Technical Note

Subject Response to NRW Comments

Further to the planning submission of the FCA for the above scheme, NRW provided comments in a formal letter dated 12.09.2019.

Figure 2 below shows the 1 in 100 year event for maximum velocity and maximum depth outside of the proposed development area.

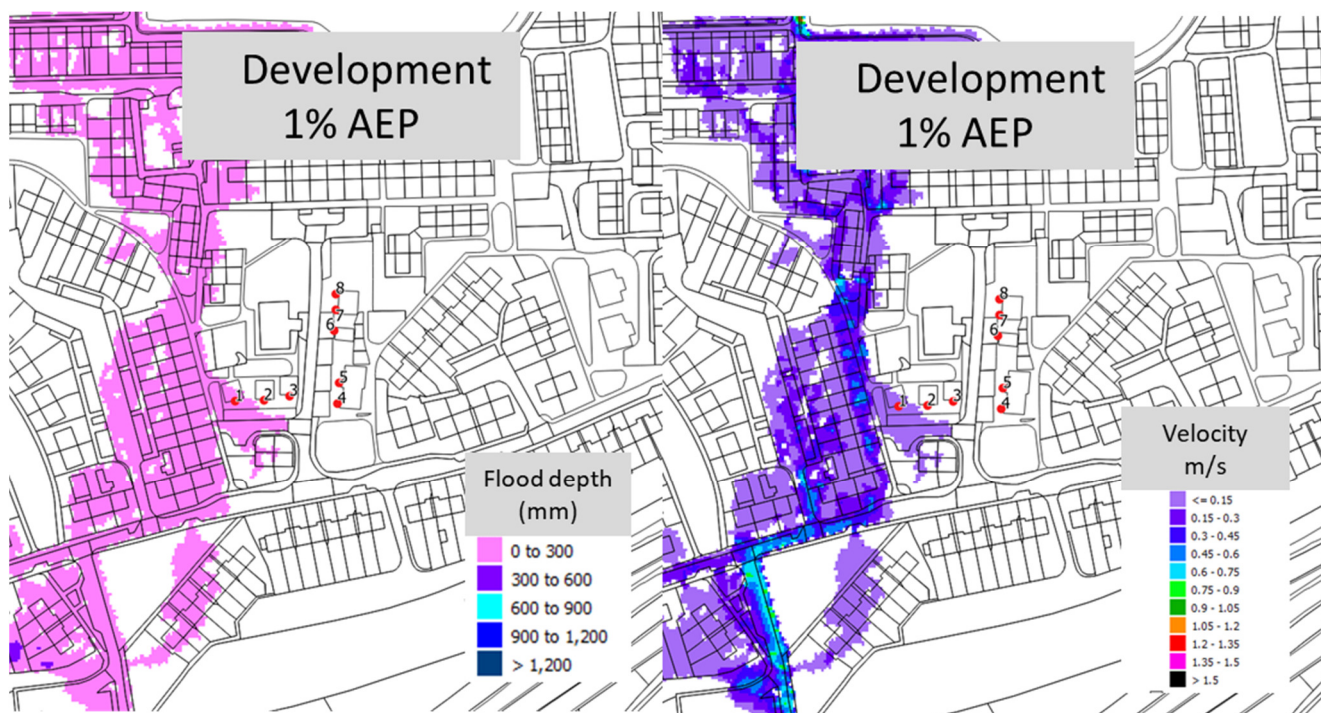
Response to NRW Comment 4

Tables 1 and 2 presented above show a summary of the flood depths and flood velocities for the North Wales Council's Regional Emergency Planning Service to refer to regarding safe access and egress.

The WSP FCA and hydraulic modelling has undertaken the "before" and "after" development comparisons of the flood velocity and hazard ratings for the site. These are included in the Appendices of the FCA and is as summarised above. WSP recommend reference should be made by the NRW to the FULL FCA report and all of its appendices. The comparisons found that the difference between the before and after development comparisons of flood velocity and hazard ratings was negligible and there was no increase in risk.
